Norfolk Vanguard Offshore Wind Farm

Statement of Common Ground

Natural England

Applicant: Norfolk Vanguard Limited
Document Reference: Rep3 - SOCG - 13.1
Revision: 3

Figure 2.1 *Sabellaria spinulosa* reef mapping by the Applicant and Natural England

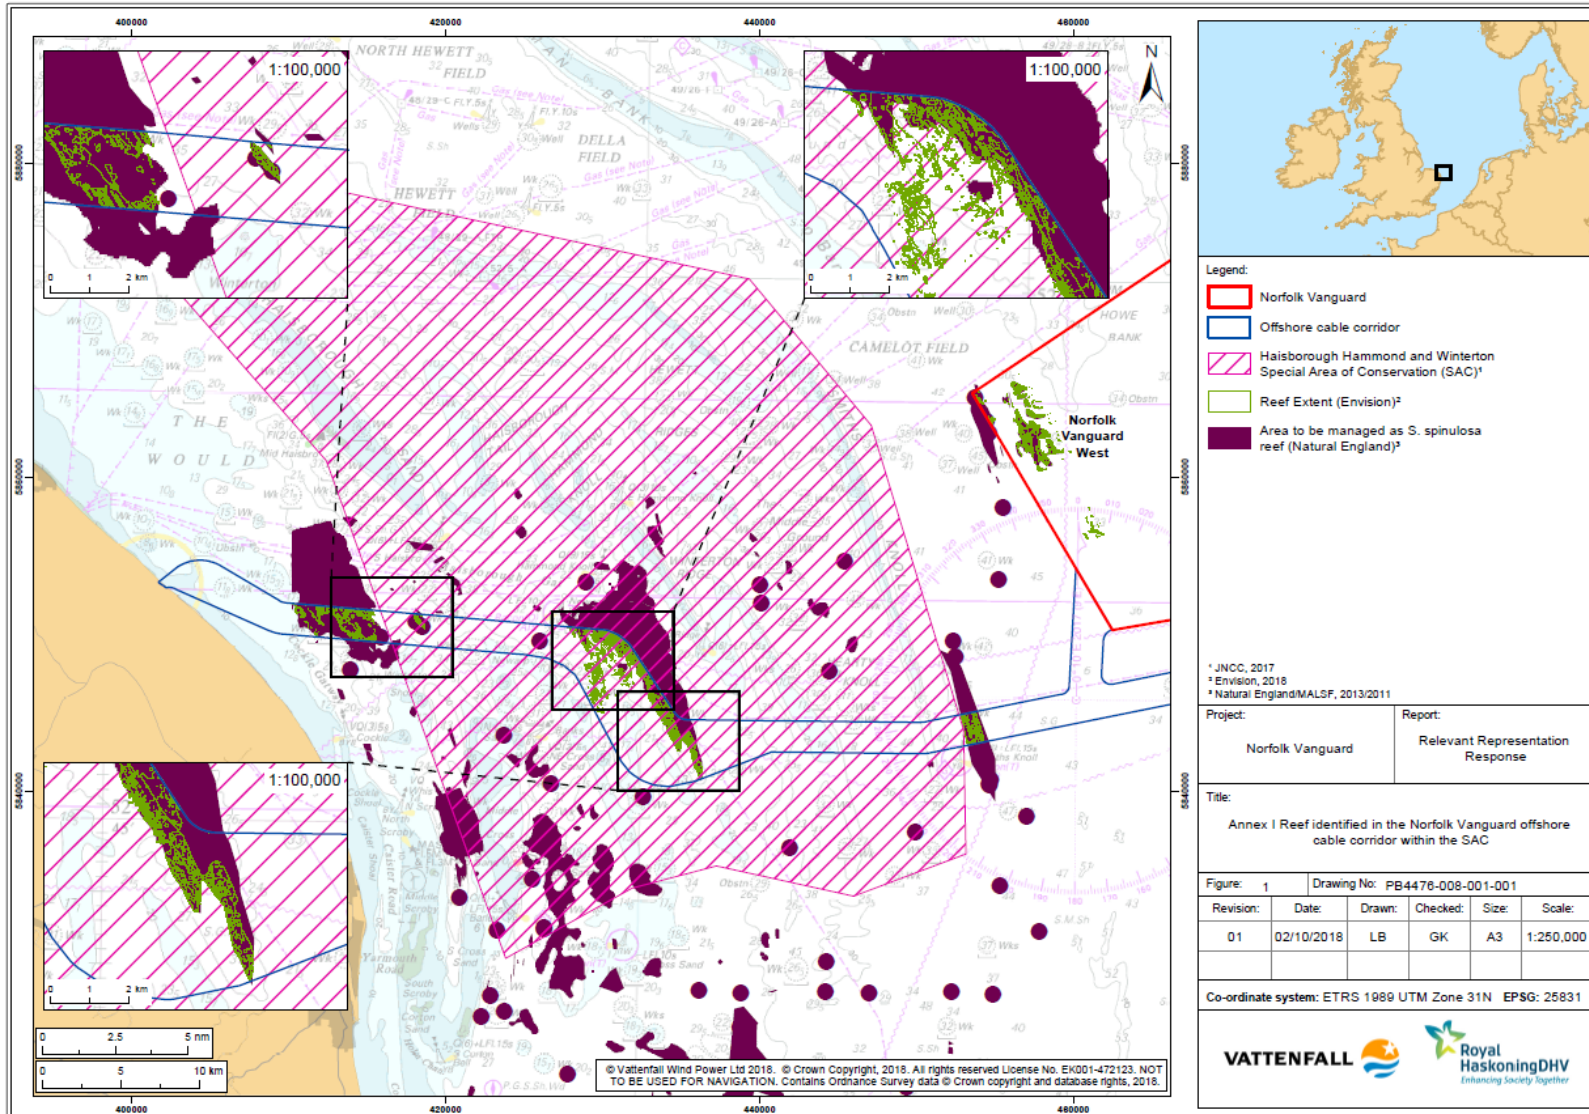
<p>The mapping of potential <i>S. spinulosa</i> reef by Envision on behalf of Norfolk Vanguard Limited identifies potential reef areas which are largely consistent with areas Natural England has identified (as shown on Figure 2.1 below).</p>	<p>Agreed</p>	<p>It is agreed by both parties that the mapping of potential <i>S. spinulosa</i> reef by Envision on behalf of Norfolk Vanguard Limited identifies potential reef areas which are largely consistent with areas Natural England has identified.</p>
	<p><i>S. spinulosa</i> is an ephemeral, rapidly growing opportunistic species; pre-construction surveys targeted at establishing the presence, location and extent of <i>S. spinulosa</i> reef habitats are therefore required to enable effective micrositing where possible.</p> <p>The assessment provides consideration of the impacts if micrositing is possible and if it is not possible (see Assessment Findings sections below).</p> <p>The HHW SAC SIP ensures that the cable routes, including micrositing must be agreed with the MMO in consultation with Natural England prior to construction. Diagram 5.1 in the Outline HHW SAC SIP outlines the</p>	<p>Parameters/clear commitments are required in the DCO rather than the simple statement “where possible”.</p> <p>Natural England would want to see that all Annex I <i>S. spinulosa</i> will be avoided.</p> <p>The impact on <i>Sabellaria spinulosa</i> reef needs to be fully assessed if micro-siting is not possible and cable installation is still permitted.</p>	<p>It is agreed by both parties that the HHW SAC SIP ensures that the cable routes, including micrositing must be agreed with the MMO in consultation with Natural England prior to construction.</p> <p>The HHW SAC SIP must also provide further consideration of the effects on <i>Sabellaria spinulosa</i> reef if micro-siting is not possible and construction can only be permitted to commence if the MMO, in consultation with Natural England, agrees that there will be no AEol.</p>
